DESIGN DS	DRAWN BY DS	DART AEROSPACE LTD VICTORIA INTERNATIONAL AIRPORT, CANADA	
CHECKED <i>[Signature]</i>	APPROVED <i>[Signature]</i>	DRAWING NO. DEO 9079	REV. B SHEET 1 OF 1
DATE 97.09.01		TITLE 205 SADDLE GROOVE CHANGE	SCALE NTS
B	98.06.22 DS	ADD 5951/5953/5955/5957

## DART ENGINEERING ORDER

TO AMEND DWG    D2571 REV. B            D5951 REV. A  
                         D2572 REV. B            D5953 REV. A  
                         D2573 REV. B            D5955 REV. A  
                         D2574 REV. B            D5957 REV. A

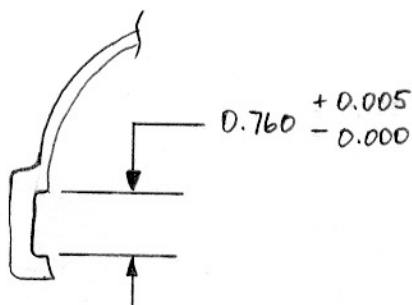
THE DIMENSION OF THE GROOVE THAT INTERLOCKS THE SADDLES ONTO THE SKIDTUBES SHOULD READ AS FOLLOWS :
